**PRELIMINARY DRAINAGE REPORT AND MDDP ADDENDUM
FOR
HOMESTEAD NORTH AT STERLING RANCH PRELIMINARY PLAN**

**July, 2021
Project No. 25188.00**

**PCD Filing No.:
SP-20-008**

EARLY GRADING - DRAINAGE MAP
 HOMESTEAD NORTH
 JOB NO. 25188.00
 06/29/21
 SHEET 4 OF 4

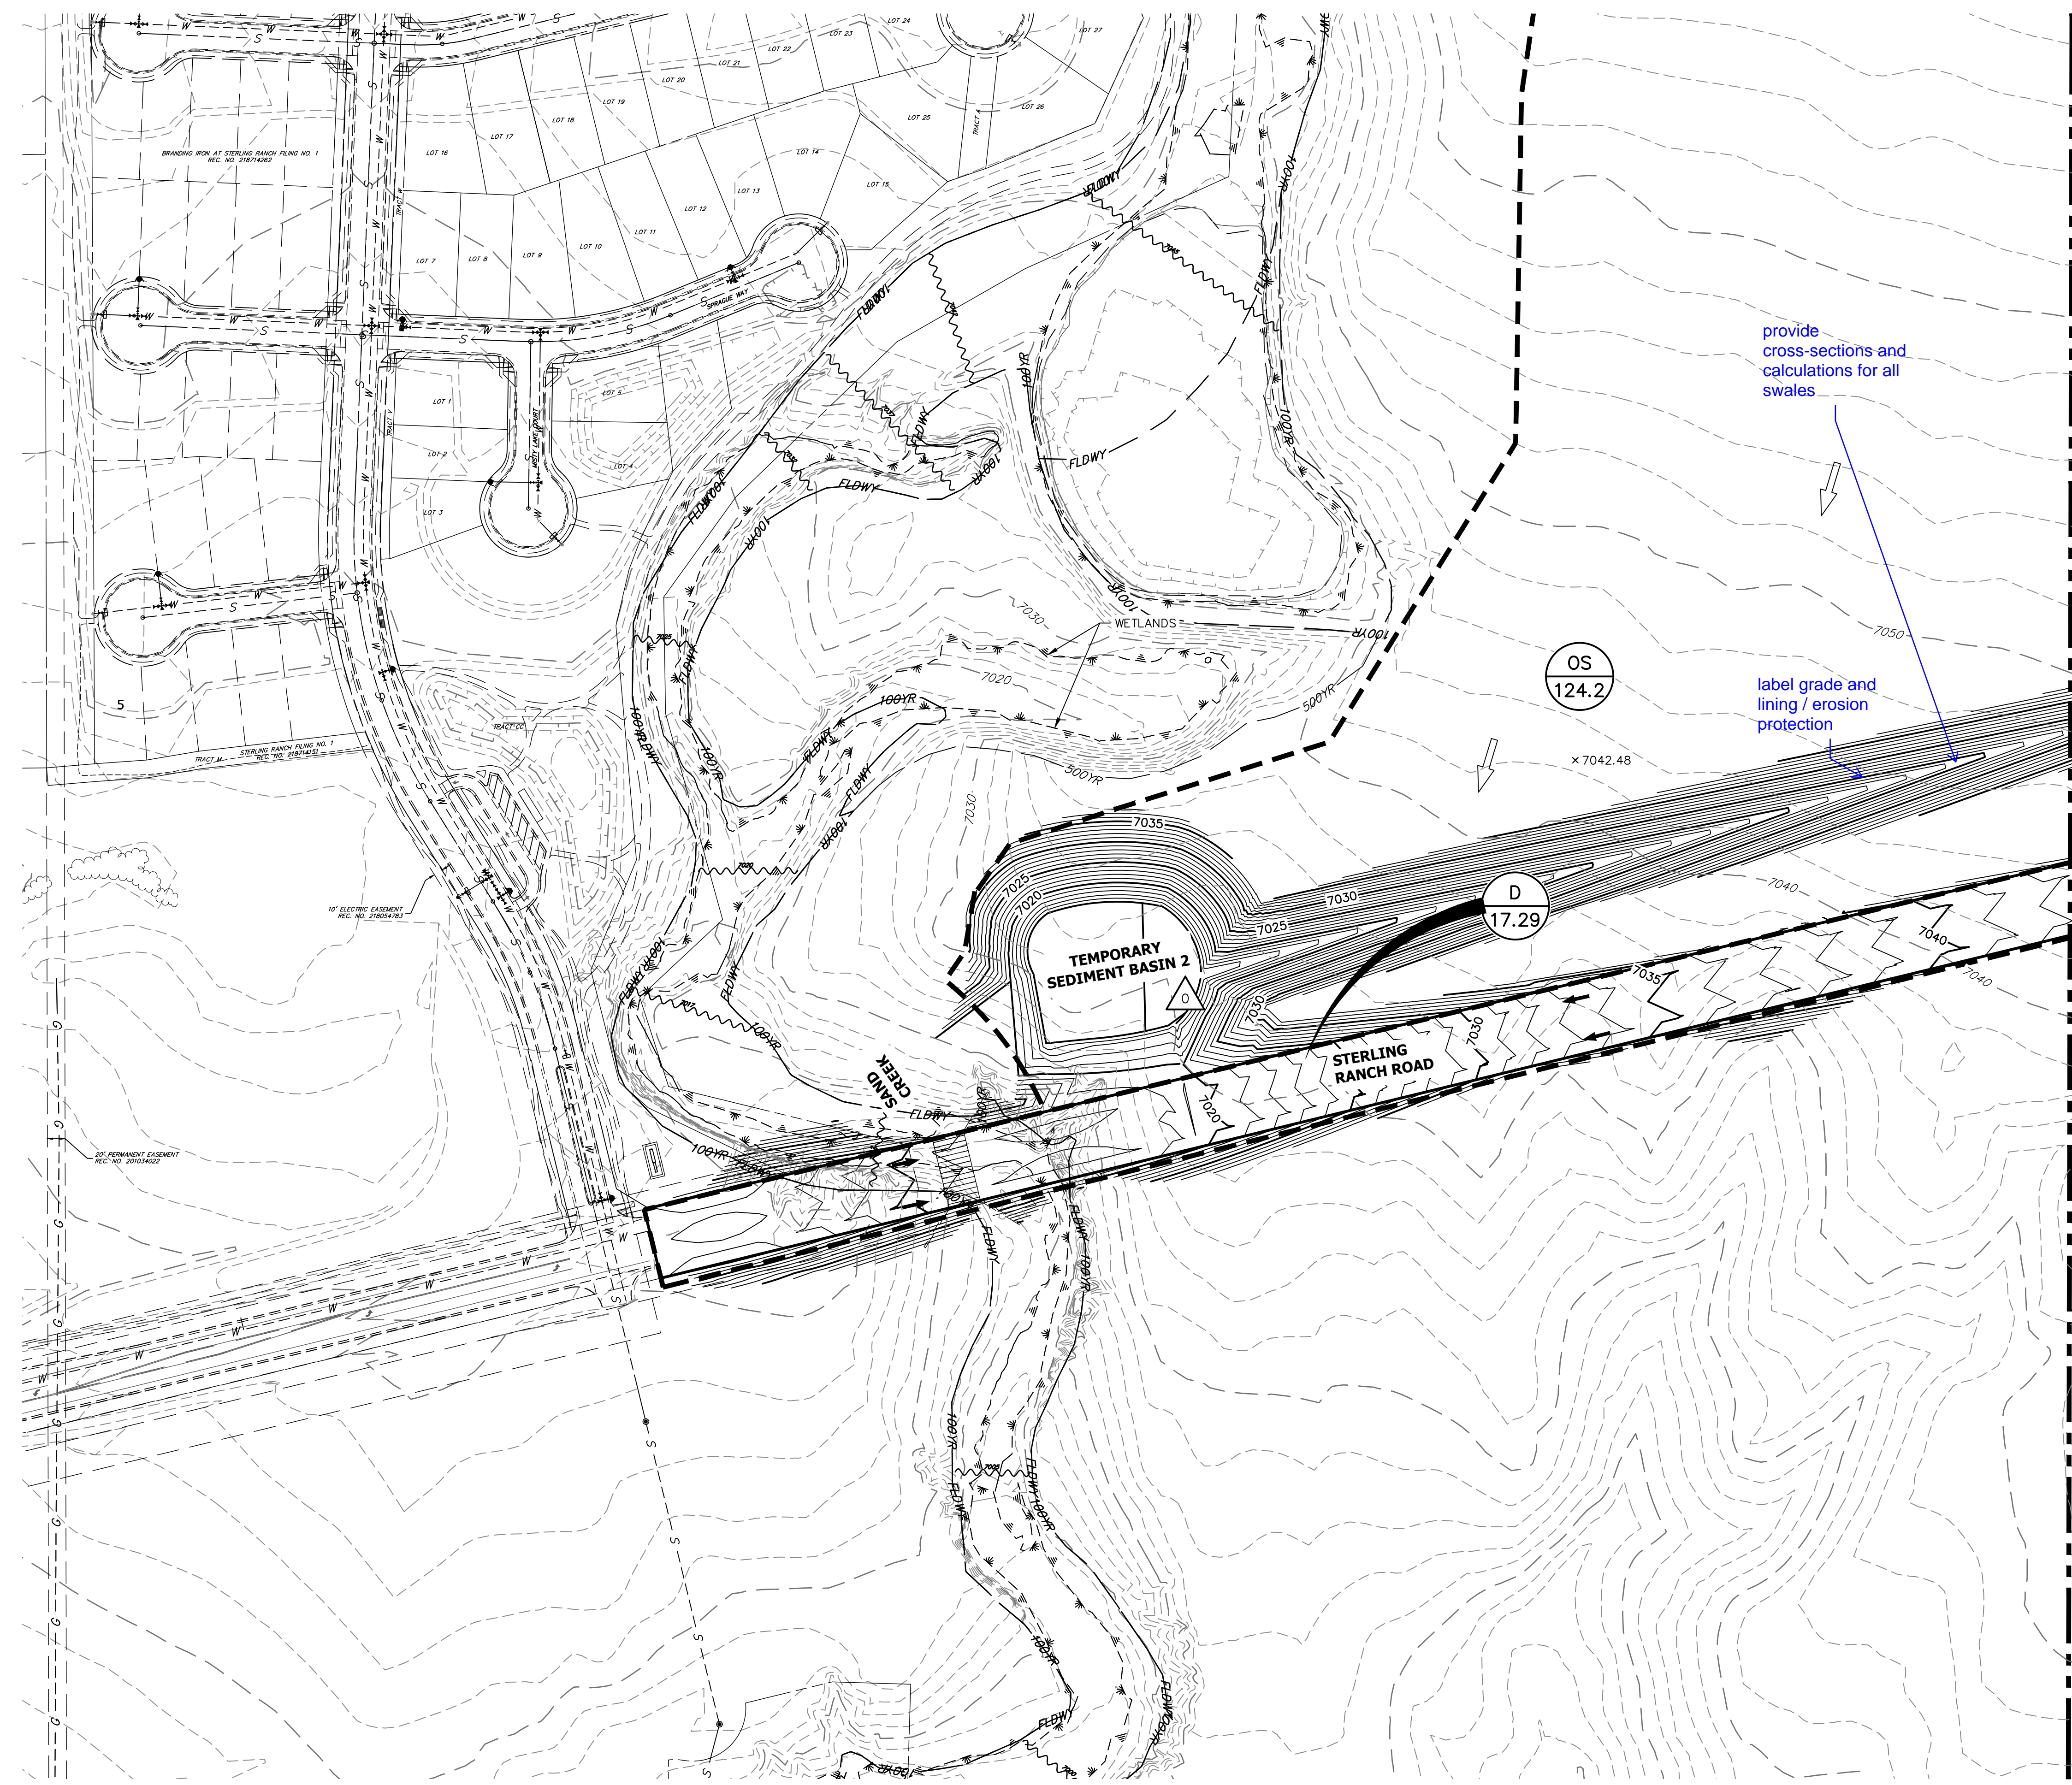
Verify size based on contributing area from east side of SRR

DRAINAGE MAP
 HOMESTEAD NORTH
 JOB NO. 25188.00
 6/28/21
 SHEET 1 OF 2

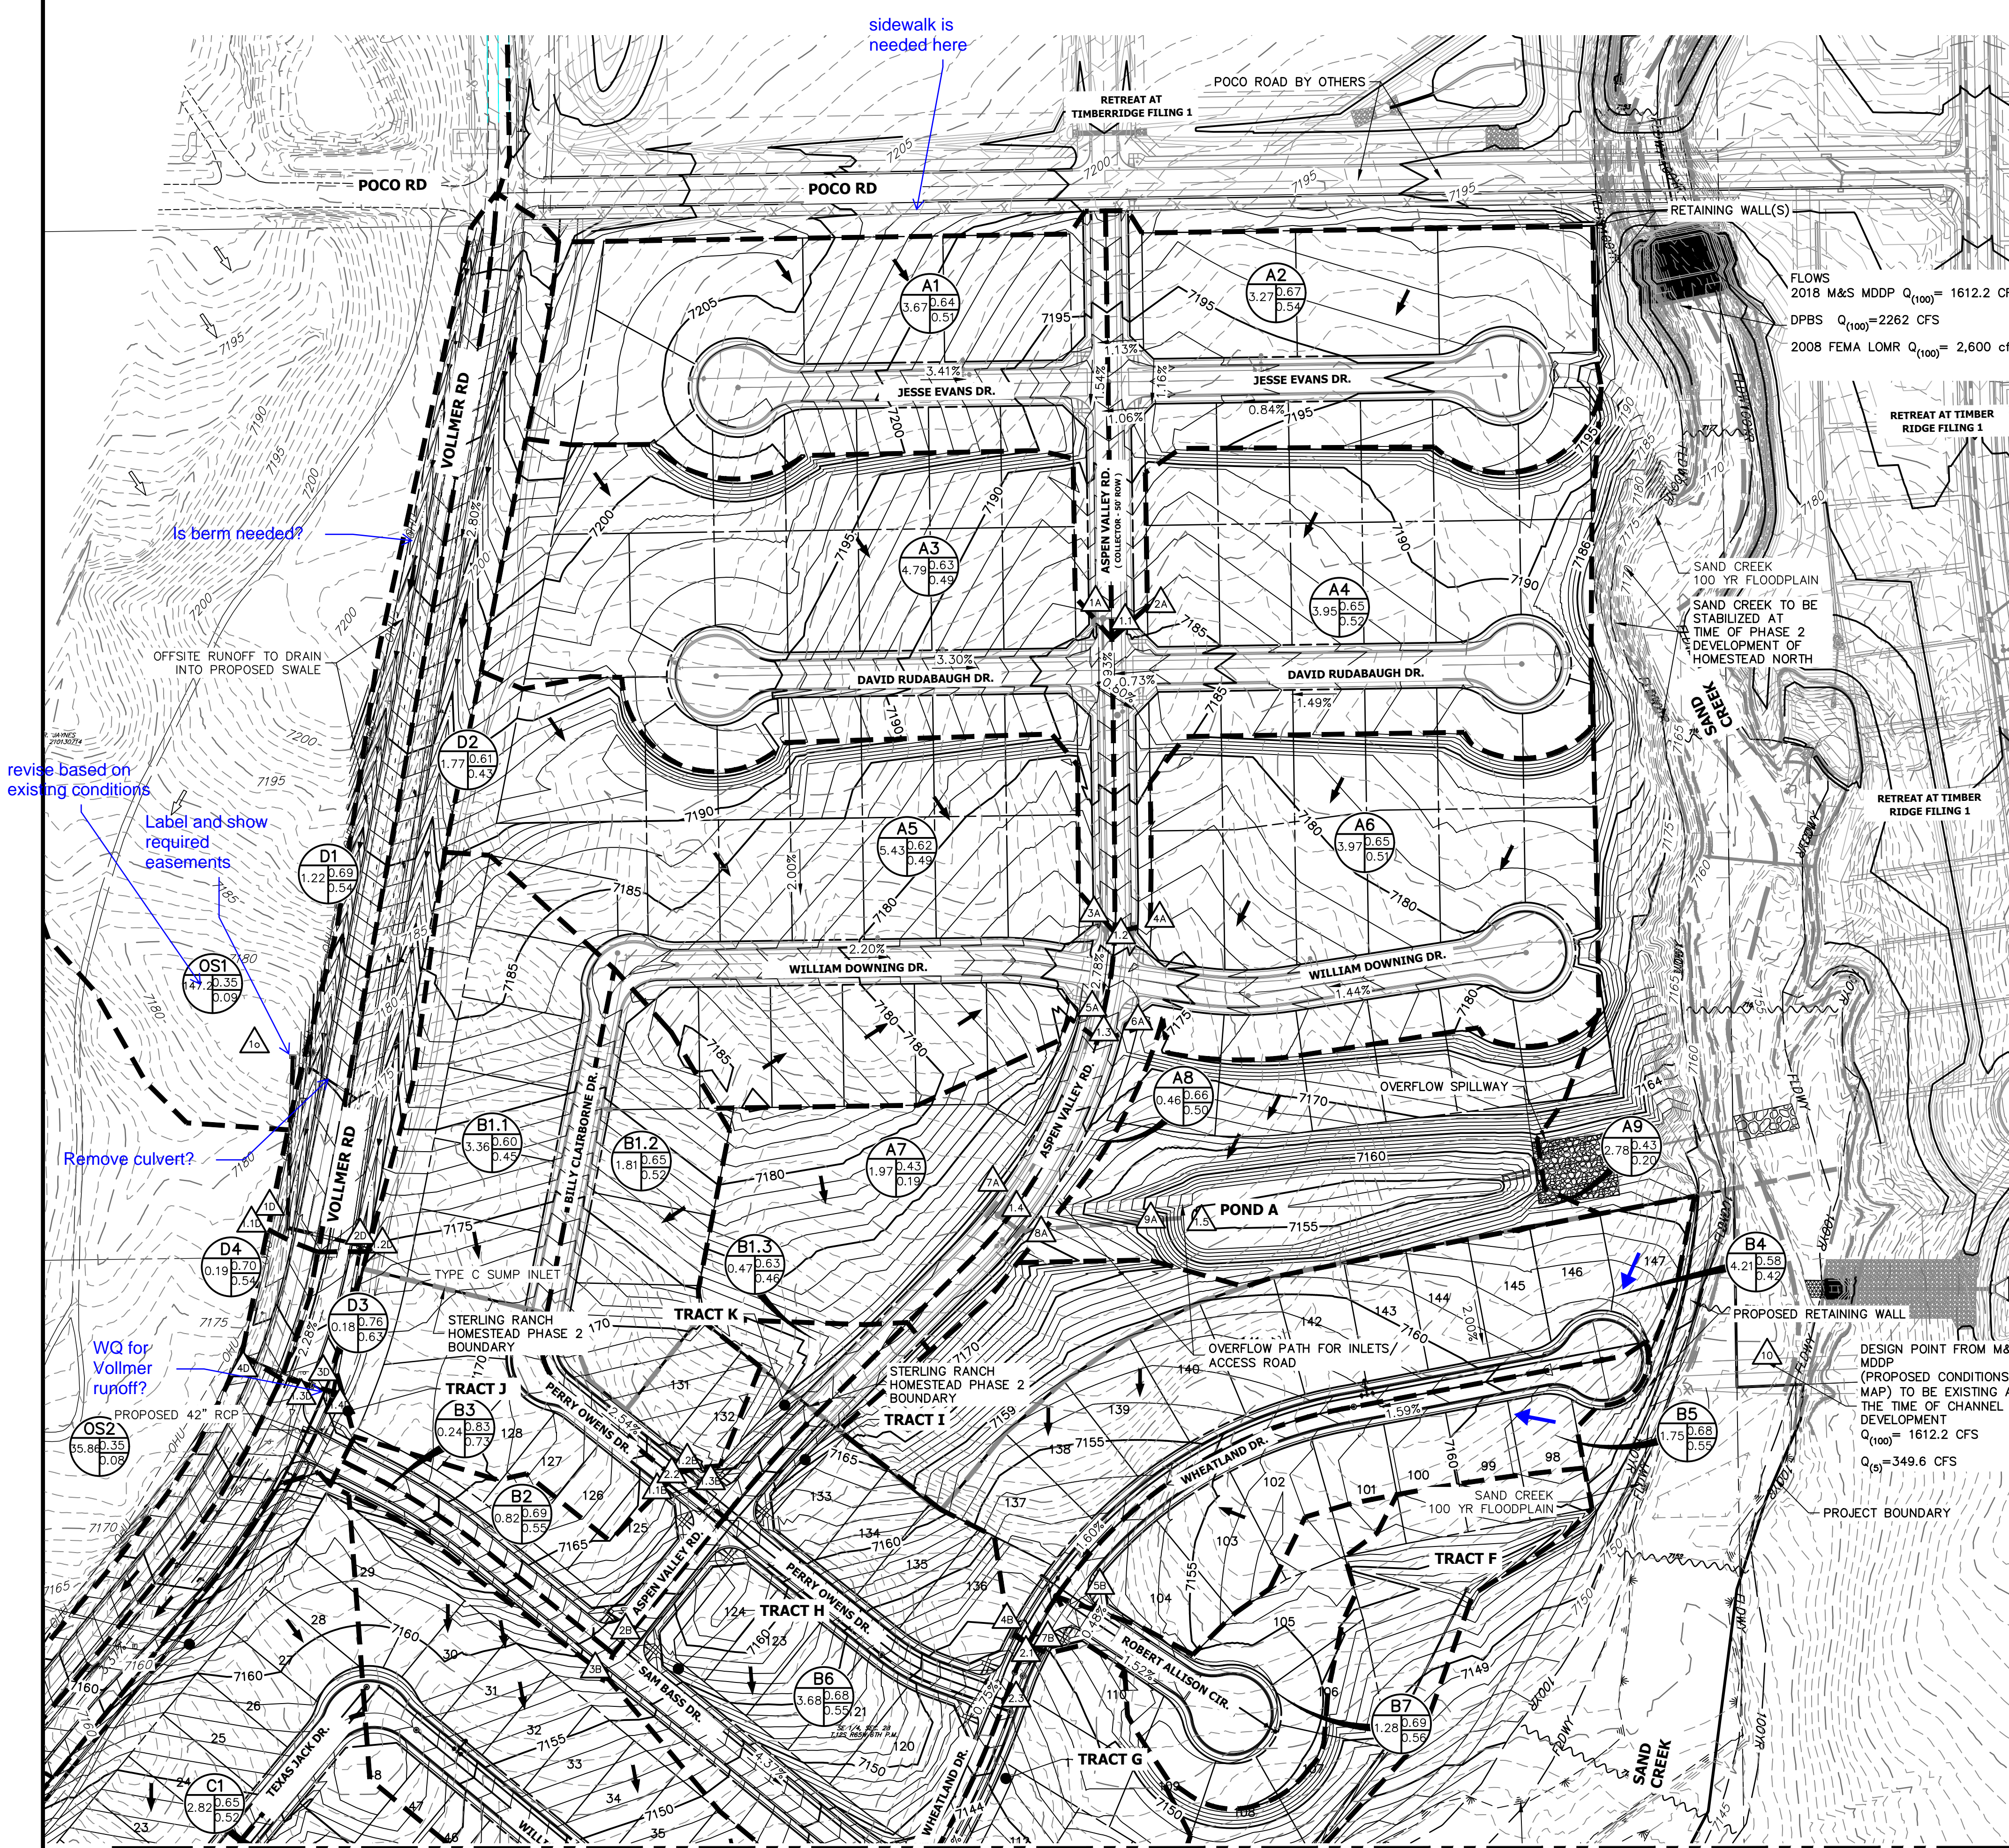
sidewalk is needed here

revise based on existing conditions

Label and show required easements

Remove culvert?

WQ -PONDS
HOMESTEAD NORTH
JOB NO. 25188.00
6-29-2021
SHEET 1 OF 1

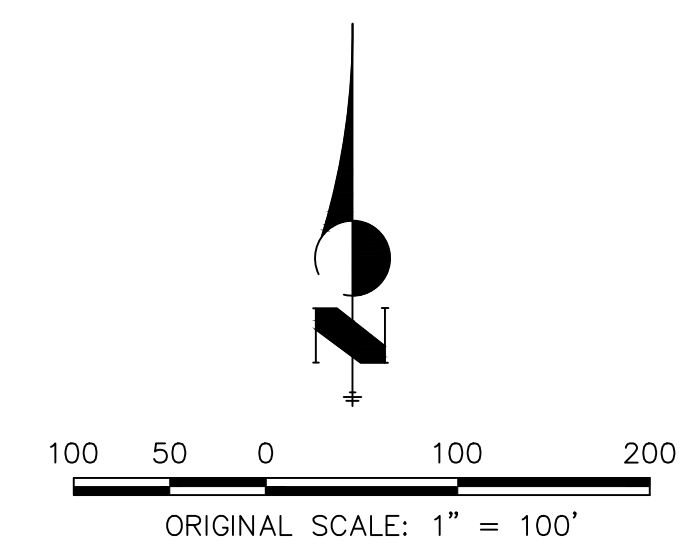
This is not acceptable unless MS4 requirements are met. Provide calculations / note how met.

Delete Note #3 - MS4 permit requirements supersede 2018 MDDP
